CENTRAL KENTUCKY BUSINESS PARK AUTHORITY

**Request for Proposals
Engineering & Design Services
Addendum #3**

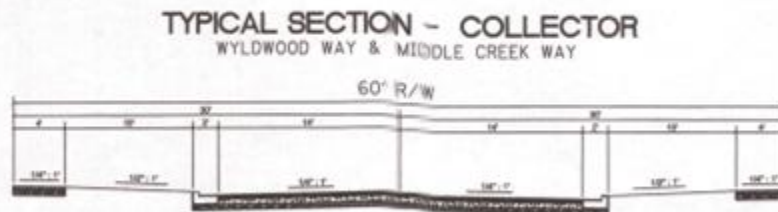
8. What is the current and proposed width of JC Chambers Lane? Is there a proposed typical section (Commercial or Industrial Section) provided in the local subdivision regulations?

JC Chambers Lane currently is approximately 12’ but the exact ROW on the current road is unknown. After improvements, JC Chambers Lane should be a collector street with 60’ ROW and a minimum pavement width of 32’. Consideration should also be given to sidewalks and shared use paths.

Berea regulations do not include typical street sections, but an example is shown below of a typical 60’ ROW section showing 6” box curbs and sidewalks on both sides.
